**GOVERNMENT OF TELANGANA
FOREST DEPARTMENT**

Ref.No.13175/2019/FCA.2, Dated:30/09/2023.

Sub: TSFD - F(C) Act, 1980 - PMGSY Roads (PR Department) - Diversion of **2.6325**
- **ha** (Revised from 4.1083 ha) of forest land for BT Road from **"R/F PWD Road to Jhaduguda** (PWD Road to Kishan Thanda) in Bheempur RF Block, Asifabad forest division of Komurambheem Asifabad District in favour of District Panchayath Raj, Engineer (PIU), Komurambheem Asifabad District- Submission of Additional information - Regarding.

MAP NO. 56
SHEET 1A, 1B, 1C, 1D, 1E, 1F, 1G, 1H, 1I, 1J, 1K, 1L, 1M, 1N, 1O, 1P, 1Q, 1R, 1S, 1T, 1U, 1V, 1W, 1X, 1Y, 1Z

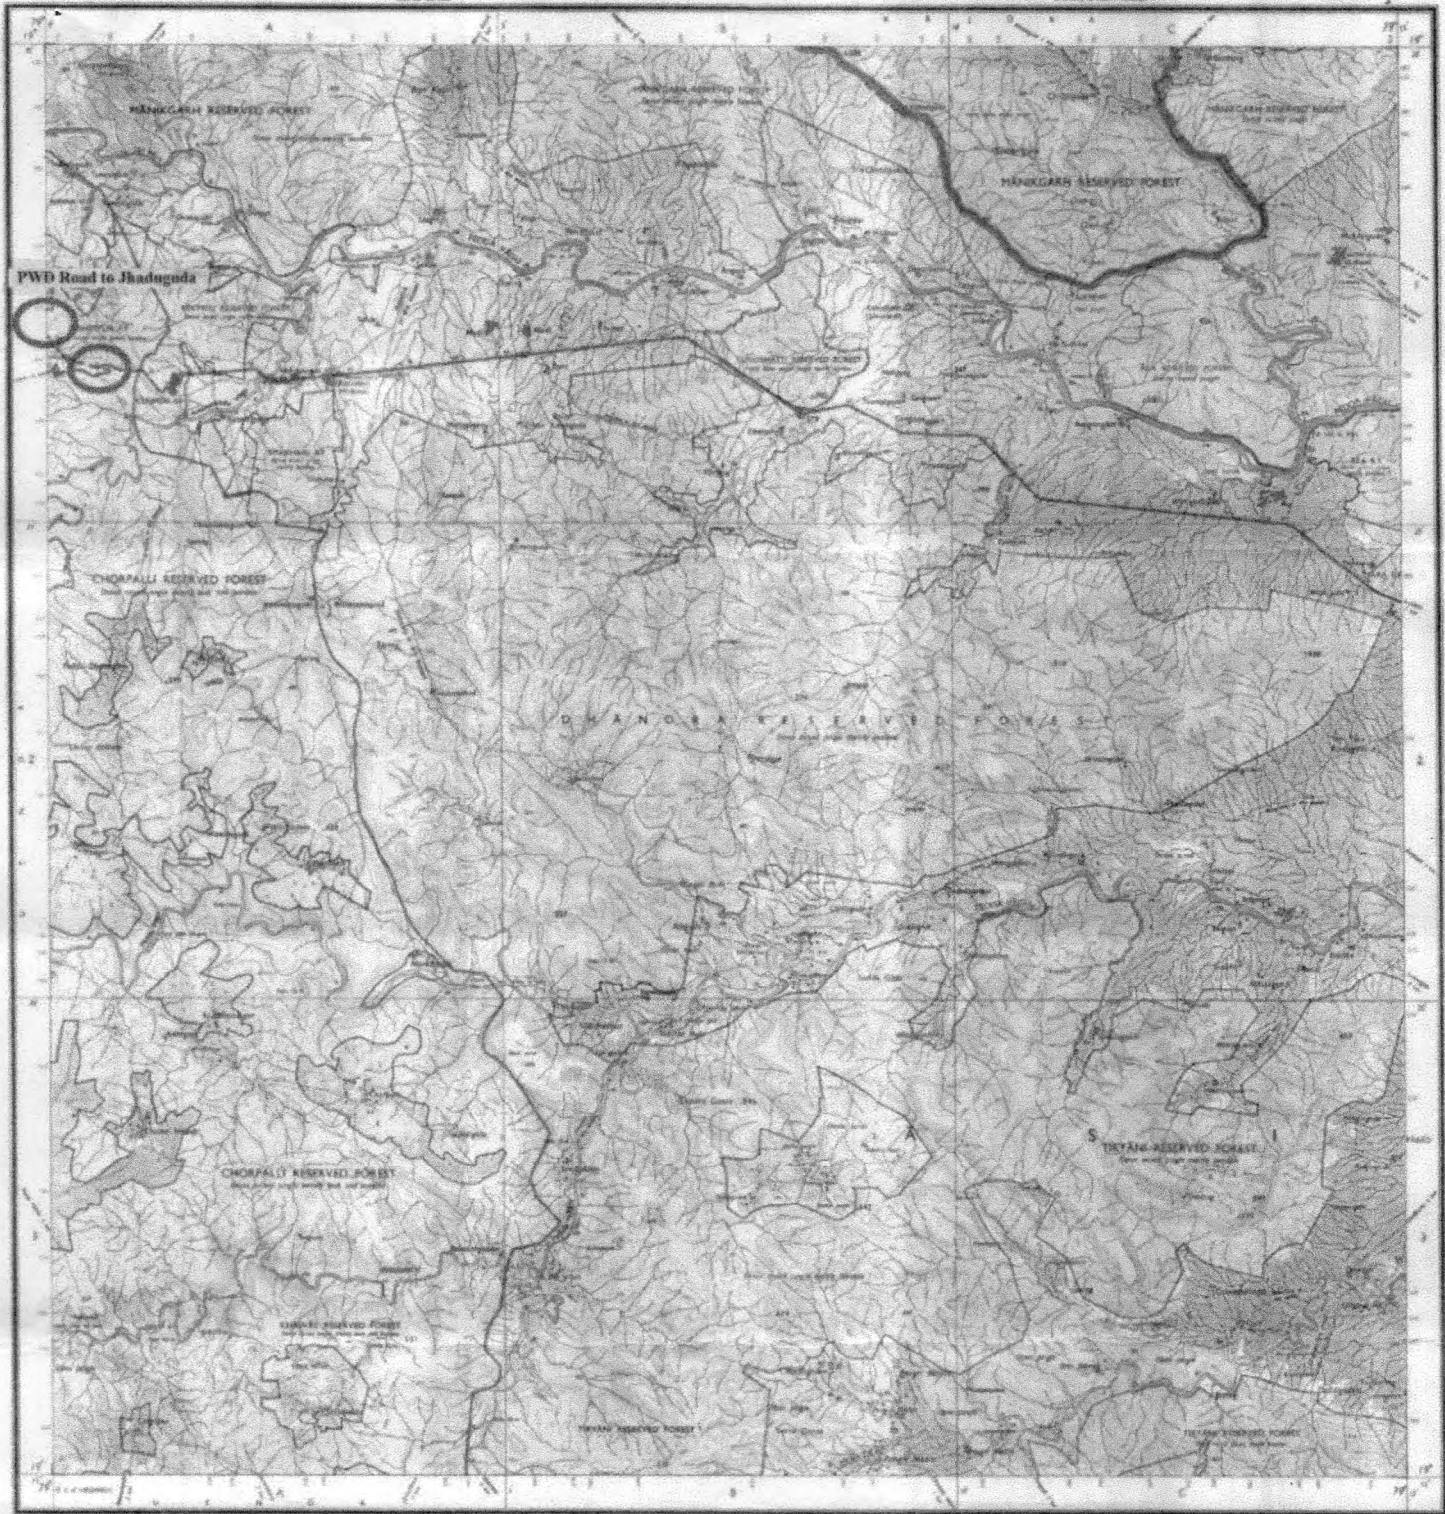
(iii)	From the Toposheet, it can seen that there are 7 bridges/culverts proposed in the forest land. However, the forest land proposed for diversion in such places is only 7.5 m width only. Specific comment is requested from the UA on whether construction of bridges/culverts is possible in the 7.5 m width proposed for diversion without breaking up the adjacent forest land not proposed for the diversion.	<p>The User agency i.e., District Panchayat Raj Engineer, Kumarambheem Asifabad vide Ltr, dt:03.08.2023 (with enclosure), has submitted that, Seven (07) number of culverts are proposed with 7.50 mts width in the forest land which is enough for construction of Seven (7) number of culverts.</p>

(ii)	Proper documentary evidence like RF notification etc., on existing road i.e., RoW allowed or otherwise, if allowed, actual length and width of the road allowed etc., shall be submitted.	The proposed road is passing through RF Bheempur. There is no explicit mention about RoW for these RF block in the available gazette notification and other documents.

1. From the toposheet, it can be seen that there are 7 bridges/culverts proposed in the forest land. However, the forest land proposed for diversion in such places is only 7.5 m in width only. Specific comment is requested from the UA on whether construction of bridges/culverts is possible in the 7.5 m width proposed for diversion without breaking up the adjacent forest land not proposed for the diversion.

As per 1980 and it is mapped on SOI (Map sheet No. 56M/4 is surveyed in 1975-76 in first edition 1982) is submitted that there was an existing cart track for an length of 1400 mtrs only out of 3510 mtrs and same is submitted herewith.
(iii)	From the Toposheet, it can seen that there are 7 brides/culverts proposed in the forest land. However, the forest land proposed for diversion in such places is only 7.5 m width only. Specific comment is requested from the UA on whether construction of bridges/culverts is possible in the 7.5 m width proposed for diversion without breaking up the adjacent forest land not proposed for the diversion.	It is submitted that, the User agency i.e., District Panchayat Raj Engineer, Kumarambheem Asifabad vide reference 2 nd cited above has submitted that, Seven (07) number of culverts are proposed with 7.50 mts width in the forest land which is enough for construction of Seven (7) number of culverts.

1. Seven (07) number of Culverts are proposed with 7.50 Mts width in the forest land which is enough for construction of Seven (07) number of Culverts.
